To: San Jose Airport Commissioners

From: The Sunnyvale-Cupertino Airplane Noise Group

RE: Special Meeting Jan 24, 2019

One Engine Inoperative (OEI) study & the corresponding recommendation as outlined in the 1/10/2019 memo to the Airport Commission from Director Aitken

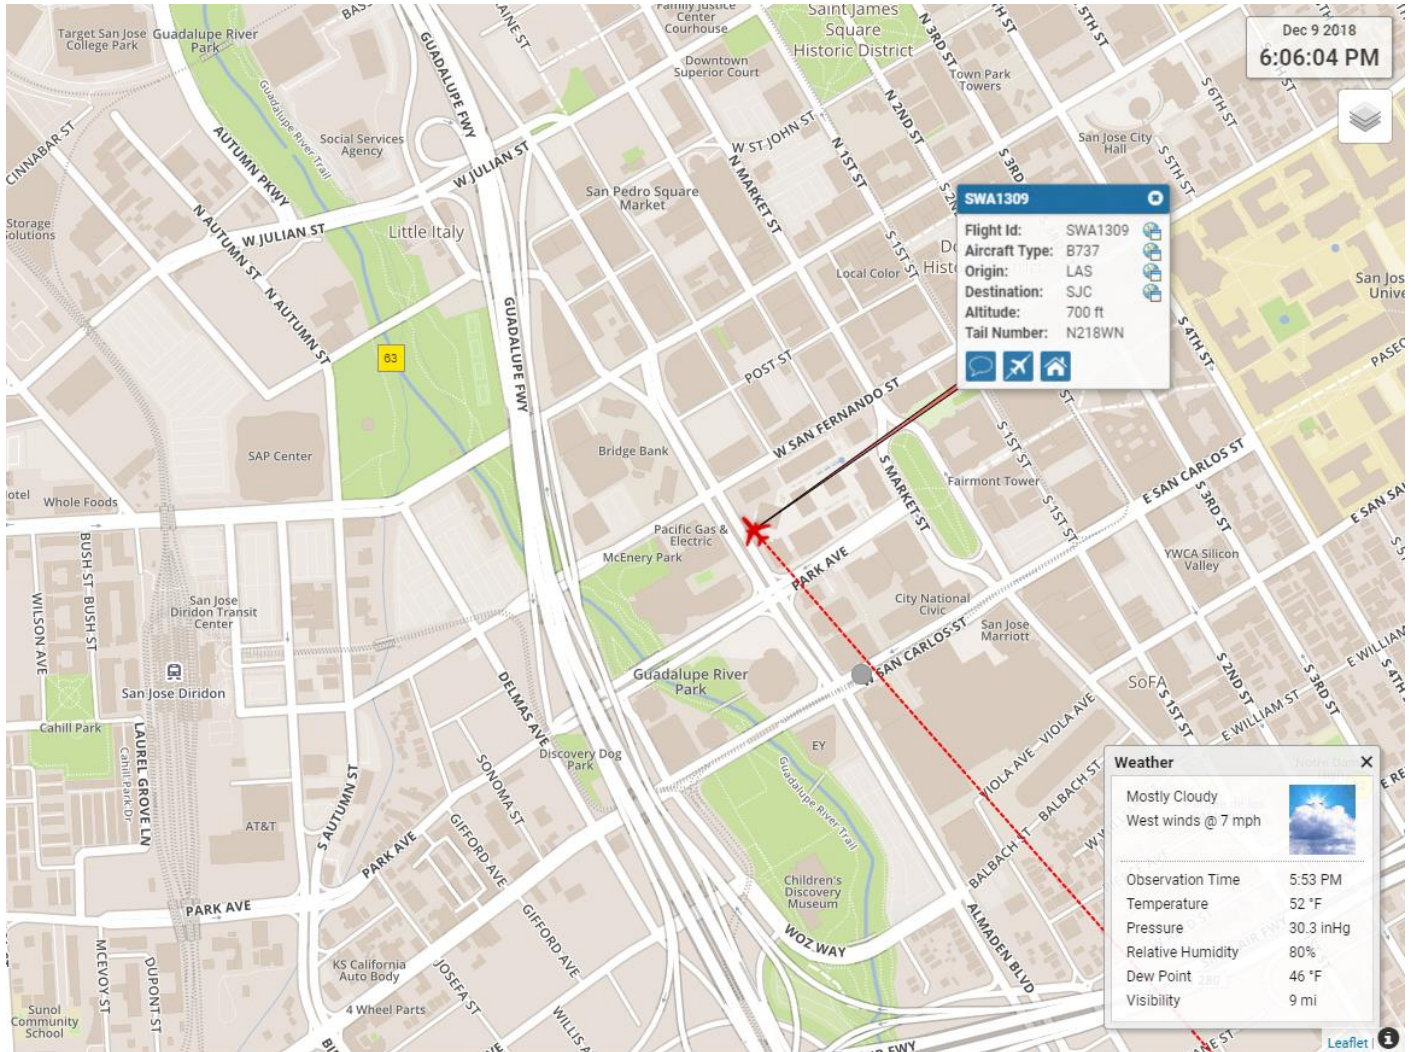
Yes, in some areas the recommendations under Scenario 4 call for minimal height adjustments, especially over downtown San Jose. Proposed height adjustments over downtown San Jose under Scenario 4 TERPS are between 5 and 35 feet; Increased heights in the Diridon area are significantly larger deltas (70 – 150 feet).

Based on San Jose Web tracker & FAA flight plates, the normal-flow arriving flights use a “straight in” flight pattern for each of the two runways 30L and 30R (during North flow). In many cases (based on San Jose web tracker altitude information), these arriving flights appear to be flying less than 500 feet above the high points of the San Jose downtown buildings.

For example, the Adobe tower at the corner of Park Ave and San Fernando Ave has a recorded height of 260 feet (per Wikipedia). Arriving flights routinely fly over this corner (per web tracker) at approx. 700-foot altitude. Although Web tracker may have some slight discrepancies in the altitudes, these normal-flow arrivals do appear to be flying very close to the tops of the current buildings. (See sample flight pictures next 2 pages.)

This might imply that even small height increases in buildings directly under the two arrival normal-flow flight paths could indirectly force the FAA to lower the south flow trigger criteria, especially if these changes result in the need for a steeper descent slope or closer proximity to building roof tops & other associated obstacles. A 35-foot change might be considered significant if arriving flights are indeed flying closer than 500 feet from the tops of the downtown buildings, which is what SJC flight tracker altitudes seem to indicate.

Sample flight flying right next to the Adobe tower at an altitude of 700 feet. The Adobe tower is 260 feet, so height delta is approx. 440 feet between the plane and the top of the building. (Approach to runway 30R)

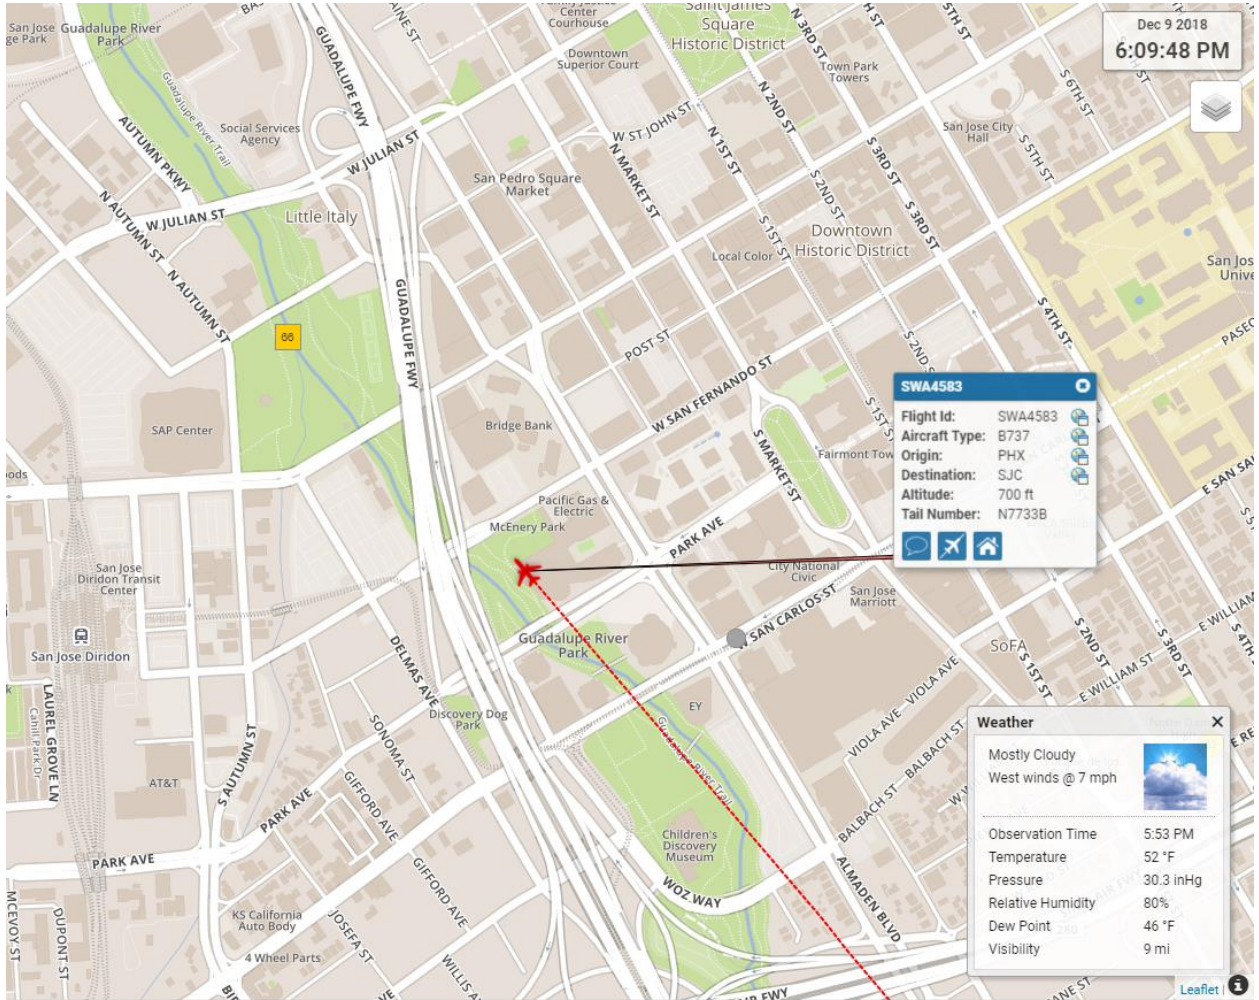
The two approach flight paths straddle the Adobe towers on each side (Approach to runway 30L). Flight at 700 foot altitude over Adobe Tower, which is 260 feet building height. Delta 440 feet (700 – 260).
